Planning and Zoning Commission

Meeting Date:	November 16, 2022	Meeting Title:	Planning Commission
Submitting Department:	Planning Department	Presenter:	Tyler Valentine
Agenda Item:	P22-141 Development Plan for two new 4-story apartment buildings at the properties addressed at 1050, 1060, and 1080 South Park Loop Road.	Public Comment:	Yes

DEVELOPMENT PLAN APPLICATION | THE LOOP HOUSING PROJECT

SHEET NO.
C7

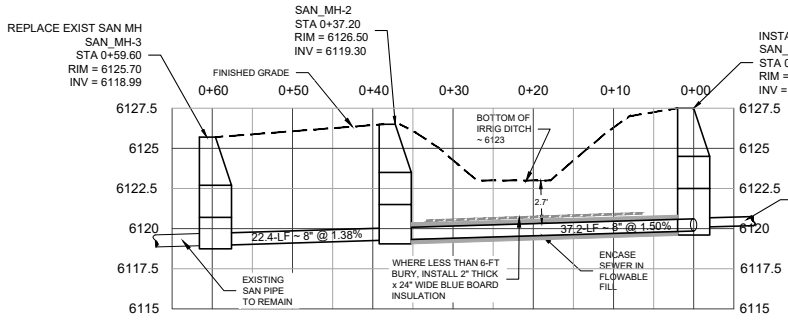
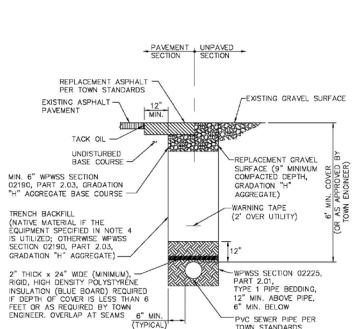
- 8. C7: Provide insulation for the sanitary sewer where the irrigation ditch crosses over with only 2.7’ of clearance. **Noted. Sheet C7 has been revised to add the insulation.**

- 9. Sheet C7 under Sanitary Sewer Note 6.1, correct “Poly” sewer pipe with “PVC”. **Noted. Sheet C7 has been revised.**
 - 10. TIS: The Traffic Impact Study should be updated to address or respond to review comments from WYDOT and Jorgensen Associates provided under separate transmittal. **The responses to the review comments have been provided as a part of this submittal.**
